Strathfield Local Planning Panel Meeting

Thursday, 7 June 2018

TO: Strathfield Local Planning Panel Meeting - 7 June 2018
REPORT: SLPP – Report No. 1
SUBJECT: DA2015/120/02 - 2-4 MINTARO AVENUE, STRATHFIELD
LOT 1 IN DP 954705 & LOT 1 IN DP 105600

Proposal: Section 4.55 (1A) modification application to amend the location and sizes of the balconies of units 1.02 and 2.02.

Figure 2: Proposed amendment to the balcony of Unit 2.02.

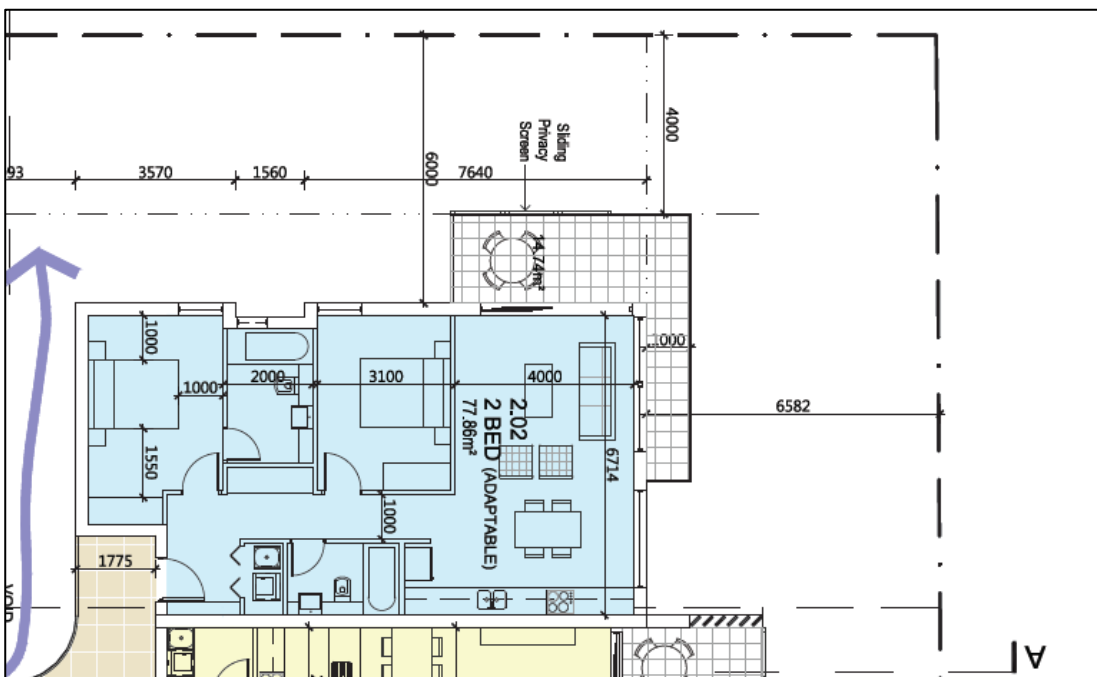
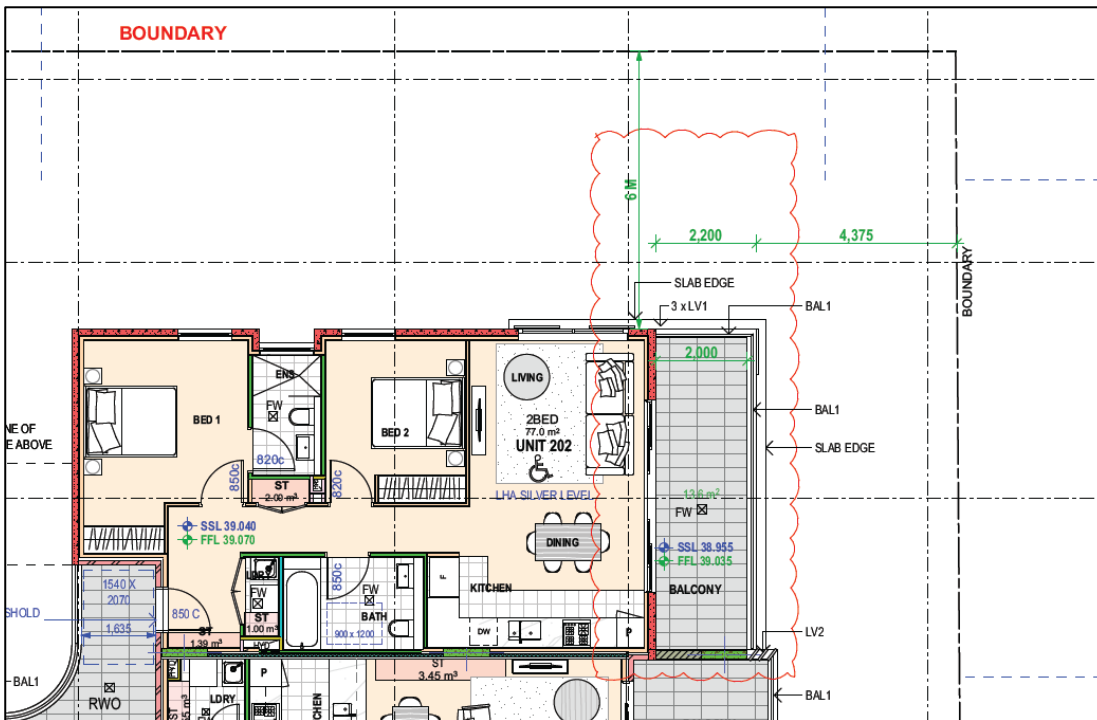
The proposed modification corrects a numerical error regarding Special Condition No. 5 of the original consent. The intent of the imposed condition was to ensure the balcony of Unit 2.02 satisfied the minimum separation distances and minimum balcony size requirements as per Objective 3F-1 and 4E-1 of the ADG. Whilst the condition identified Unit 2.02, the applicant raised that the location including separation distance is duplicated on the Unit 1.02 balcony directly below.

The modification application proposes to re-locate the balconies of Units 1.02 and 2.02 to orientate towards Mintaro Avenue. The modification will provide the development with a minimum side setback of 6m from the western boundary, a compliant front setback to Mintaro Avenue as well as compliance with the area and depth requirements for 2 bedroom balconies (illustrated in Figures 1 and 2 below).

*"Prior to the issue of a Construction Certificate, amended plans shall be prepared and approved by the Principal Certifying Authority relocating the balcony to Unit 2.02 toward the front boundary to provide a minimum 6m setback to the western boundary. The balcony to unit 2.02 shall be **2m** in depth and 10m². The balcony shall be provided with a glass balustrade to the west and northern elevations so that it is open-form in appearance."*
